#### **NORTH ANNA EARLY SITE PERMIT APPLICATION**

**Final Safety Evaluation Report Review Items**

### **Correction of Coordinates for ESP Site Footprint**

**DOMINION NUCLEAR NORTH ANNA, LLC**  
**NORTH ANNA EARLY SITE PERMIT APPLICATION**  
**RESPONSE TO NRC QUESTIONS AND REVISION 6 TO THE NORTH ANNA ESP**  
**APPLICATION**

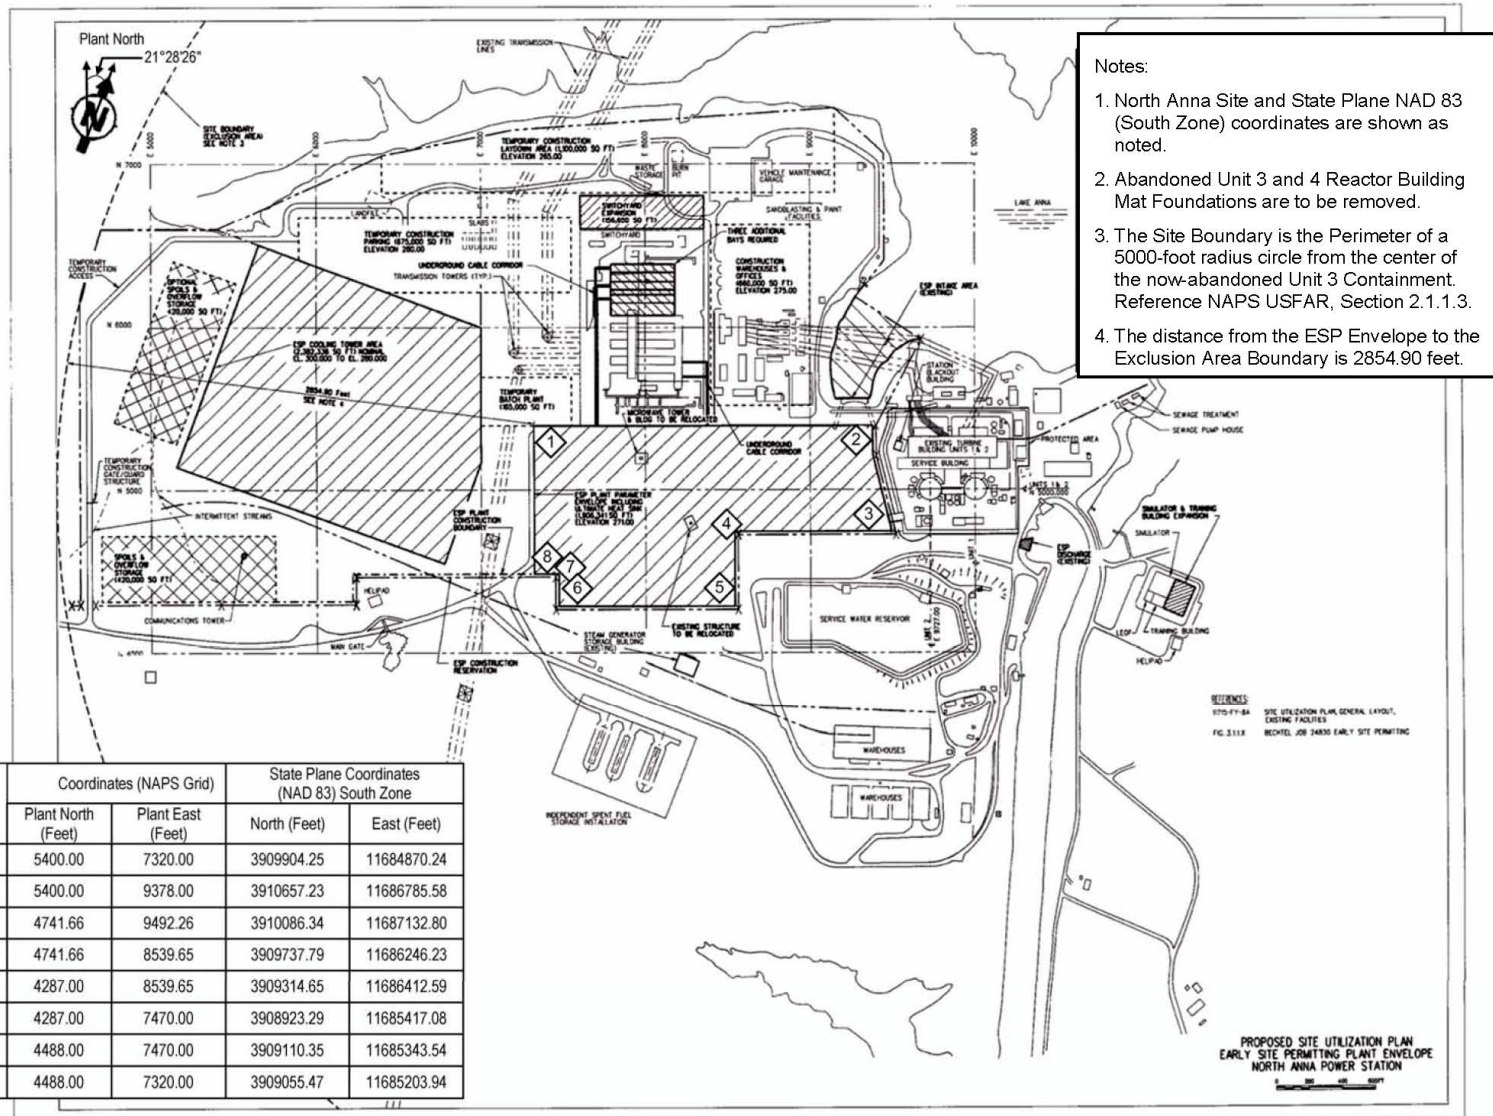
Coordinates for the ESP site footprint were submitted to the NRC in response to Draft Safety Evaluation Report (DSER) Open Item 2.4-1 (Dominion Letter 05-785B dated March 3, 2005).

As discussed in a July 5, 2005 conference call with NRC Staff, upon further review, it has been determined that the coordinates identified in Figure 1 of the DSER Open Item 2.4-1 response contained errors.

A corrected version of Figure 1 is provided on the next page.

**Figure 2.5-55A** Selected Horizontal and Vertical OBE and SSE Spectra for the Hypothetical Rock Outcrop Control Point at the Top of Zone III-IV Material (Representative Elevation 250 ft, 3300 ft/sec Shear Wave Velocity)

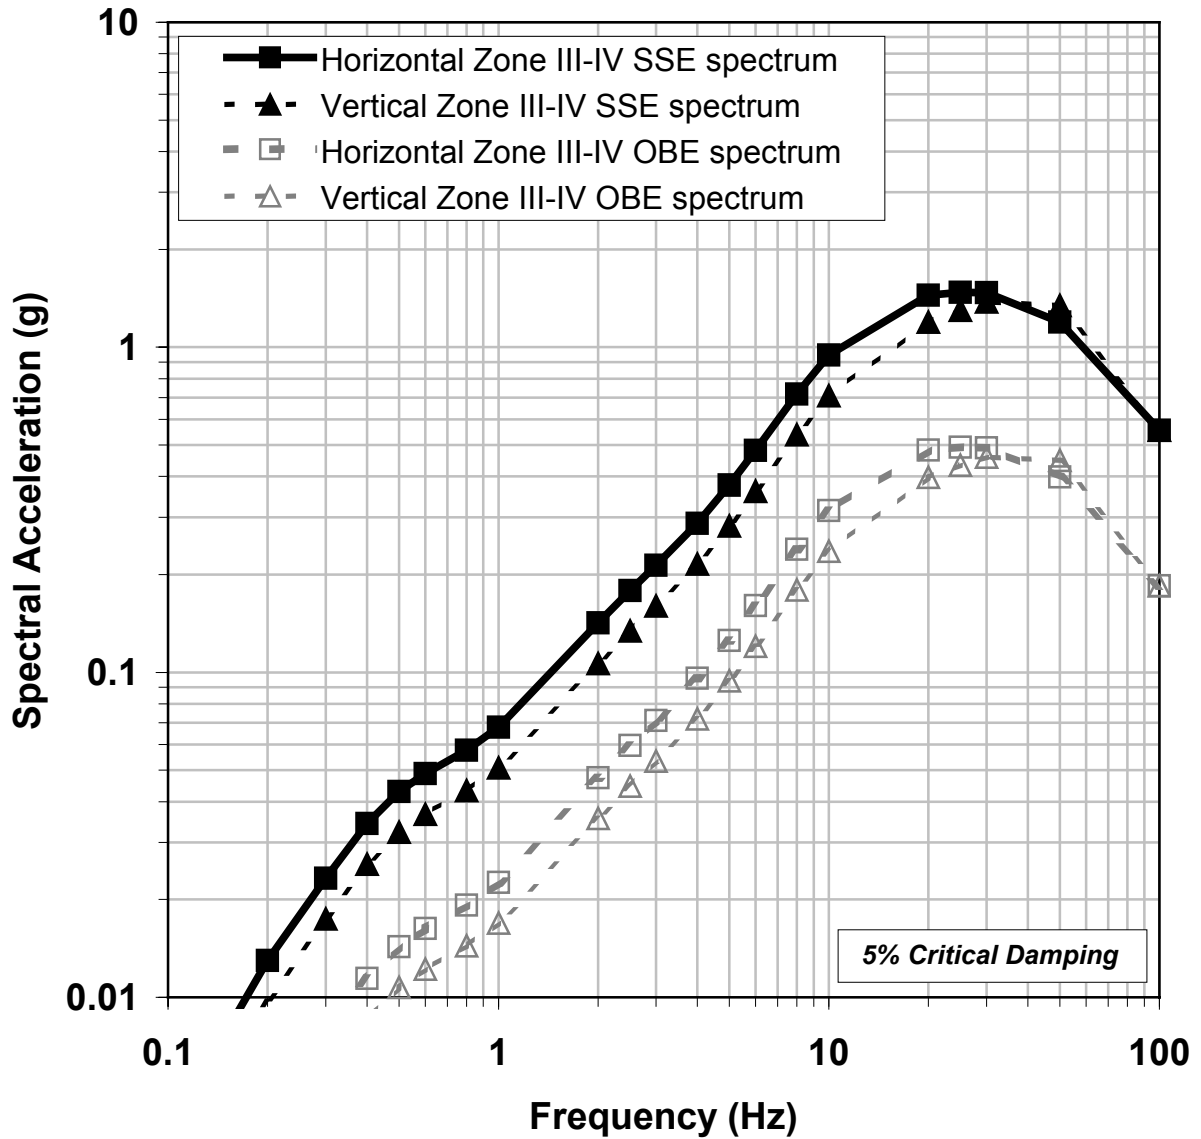
### **Incorrect Version of SSAR Figure 2.5-55A**

In Dominion's response to DSER Open Item 2.5-2 (Dominion Letter 05-194 dated March 30, 2005), a new SSAR figure, Figure 2.5-55A, was included titled:

Revision 4 of the North Anna ESP Application included an incorrect version of SSAR Figure 2.5-55A. (A duplicate copy of SSAR Figure 2.5-55 was inadvertently included as SSAR Figure 2.5-55A.)

The correct version of SSAR Figure 2.5-55A has been incorporated in Revision 5 of the ESP Application.

In Revision 5 of the ESP Application, SSAR Figure 2.5-55A has been replaced with the correct version shown on the next page.

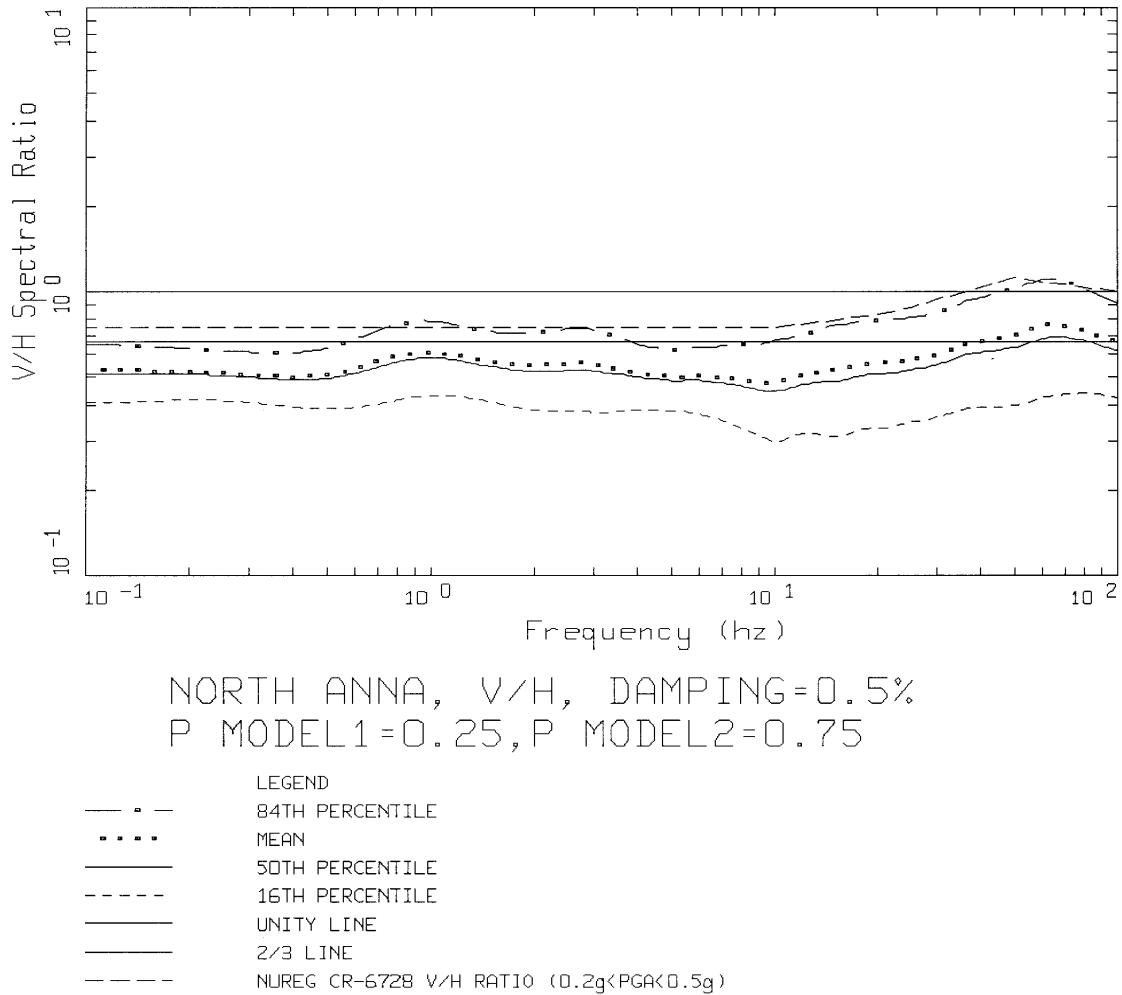
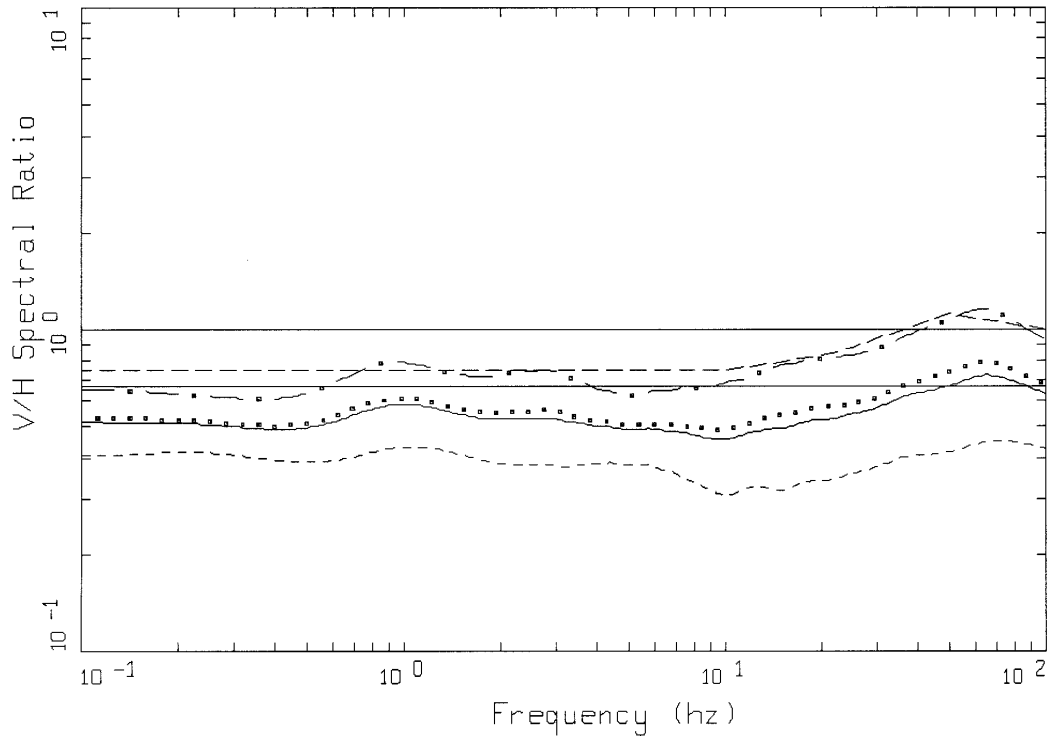
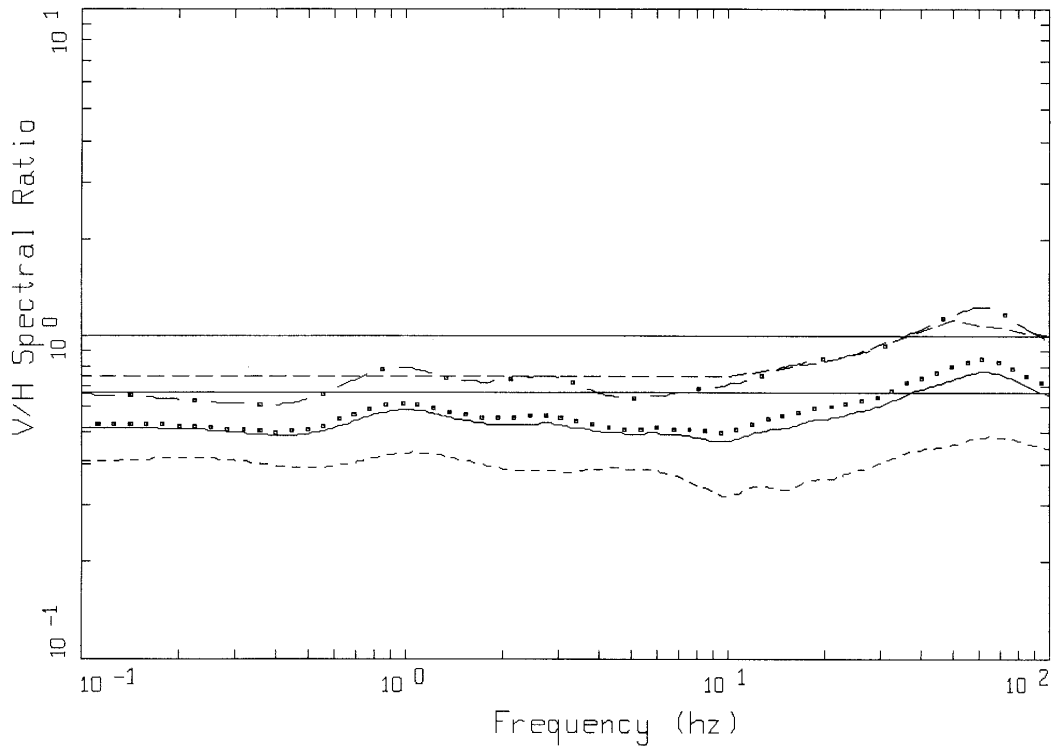
The statistical results of the V/H spectral ratios for the 0.5% damping level are shown in Figure 2. For comparison purposes, the V/H ratio for the 0.2g<PGA<0.5g bin from NUREG/CR-6728, which was used in SSAR Table 2.5-27A, is shown in Figure 2.

The 16<sup>th</sup>, 50<sup>th</sup>, and 84<sup>th</sup> percentiles and mean V/H ratios are shown in Figure 4 for the 2.0% damping case and listed in Table 2. For comparison, the V/H ratios from NUREG/CR-6728 for the 0.2g<PGA<0.5g case, which was used for SSAR Table 2.5-27A, are also shown in Figure 4 and listed in Table 2. On average, the mean V/H ratios from the site-specific analysis are approximately 30% lower (ranging from 18-35% lower) over the complete frequency range of 100 Hz to 0.1 Hz than the V/H ratios used in SSAR Table 2.5-27A. At the 84<sup>th</sup> percentile, the site-specific V/H ratio values are on average 8% lower (ranging from 19% lower to 5% higher) over the entire frequency range than the SSAR Table 2.5-27A V/H ratio values.

The comparison results provide justification that the V/H ratios given in NUREG/CR-6728 and used in SSAR Table 2.5-27A are appropriate for the North Anna ESP site. To maintain a hazard-consistent level in scaling the horizontal ground motions, the fractile level needed for the V/H ratio is between the 50<sup>th</sup> and 84<sup>th</sup> percentile. The exact percentile level would depend on frequency, site, design considerations, and judgment.

In Revision 5 of the ESP Application, SSAR Section 2.5.2.6.7.d has been revised to read as follows:

The comparison results provide justification that the V/H ratios given in Reference 171 and used in Table 2.5-27A are appropriate for the North Anna ESP site. To maintain a hazard-consistent level in scaling the horizontal ground motions, the fractile level needed for the V/H ratio is between the 50<sup>th</sup> and 84<sup>th</sup> percentile. The exact percentile level would depend on frequency, site, design considerations, and judgment.

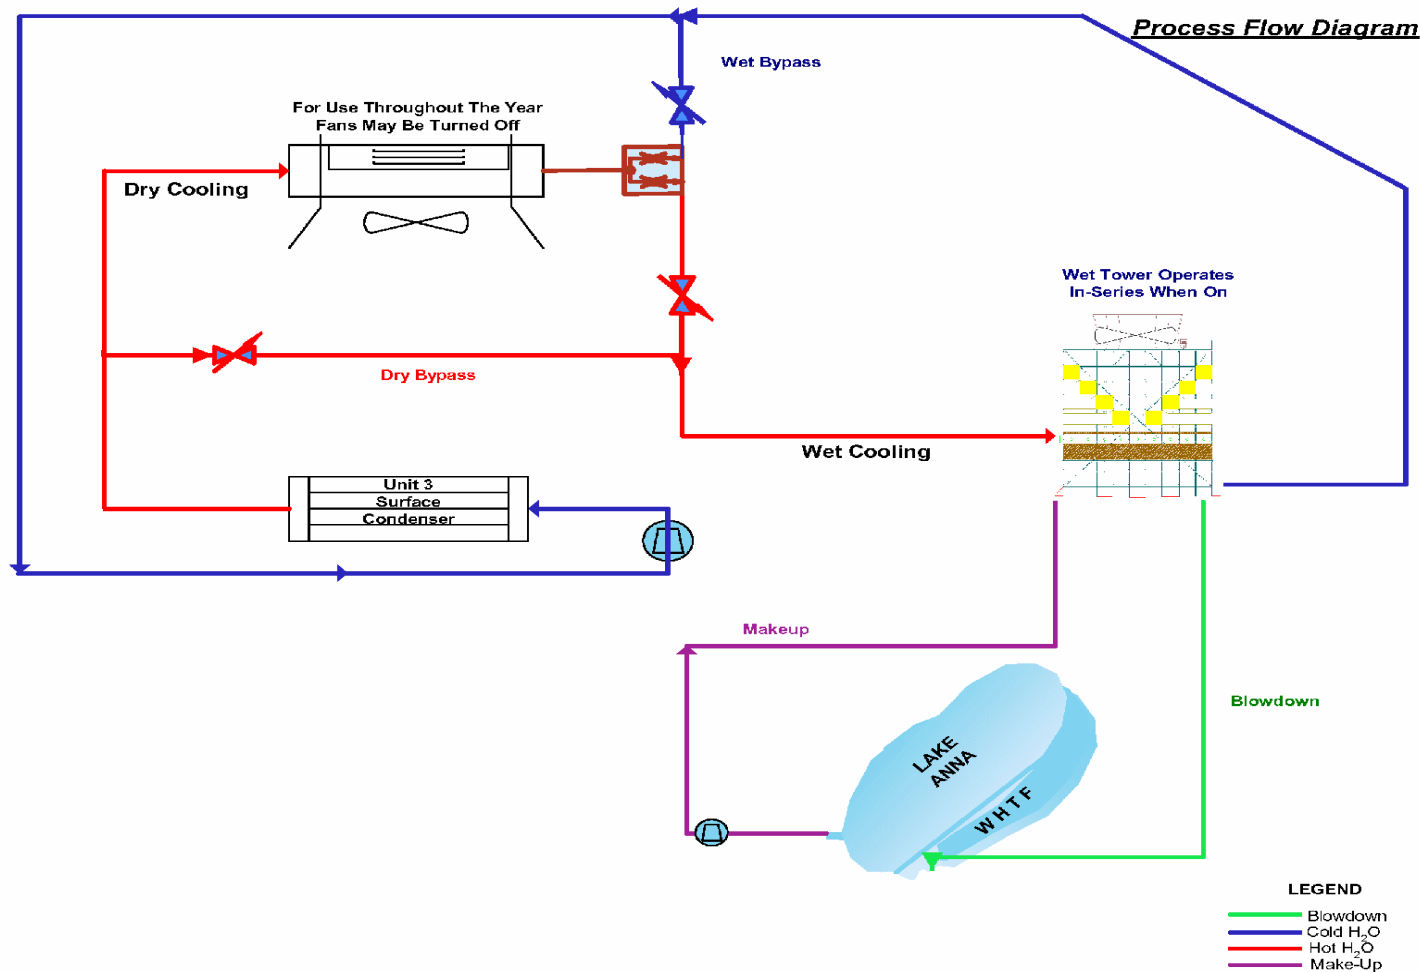
**3 Response**

The normal plant cooling system is a closed cycle system combining dry and wet cooling towers to provide the capability to reduce water consumption during drought conditions. The process flow diagram for the system is shown in the attached Figure. In the Maximum Water Conservation (MWC) mode of operation, heated cooling water leaving the plant main condenser would be cooled in a dry cooling tower section where a minimum of one-third of the heat would be rejected. The cooling water passes through the tubes of the dry cooler while fans move air across the outside of the tubes to transfer the heat to the air. After passing through the dry coolers, the water then passes through a wet cooling tower section, where the remaining heat is dissipated by spraying the water into an air stream, achieving the majority of the heat transfer by evaporation of a portion of the water. The cooled water then returns to the plant condenser to condense the steam leaving the turbines. When the system is in the Energy Conservation (EC) mode of operation, the dry tower fans are turned off with 100% of the cooling then provided using the wet tower section.

Several features are available for conserving water in wet cooling towers. A hybrid tower can be used that incorporates a dry cooling section into the top of the wet cooling tower. A portion of the water entering the tower passes through the tube side of a heat exchanger while air is drawn or forced over the tubes before mixing with the air that has passed through the wet section. This configuration increases the heat transfer due to convection and conduction and reduces the amount of evaporation required to achieve the desired return temperature to the condenser.

A variation of the hybrid tower uses a dry section above the wet tower section where cooler outside air is drawn in through ducts while the warm moist air from the wet section exhaust passes over the outside of the ducts. Water from the wet section exhaust condenses on the cooler dry section duct surfaces and falls back into the process stream before leaving the cooling tower, thereby reducing the water loss due to evaporation.

ER Section 3.4.1.1 is revised to include the diagram of the cooling system shown in the attached Figure and to describe examples of the water saving features that could be used in the wet towers. The figure in the ER Section also includes a plant service water system described in the section.
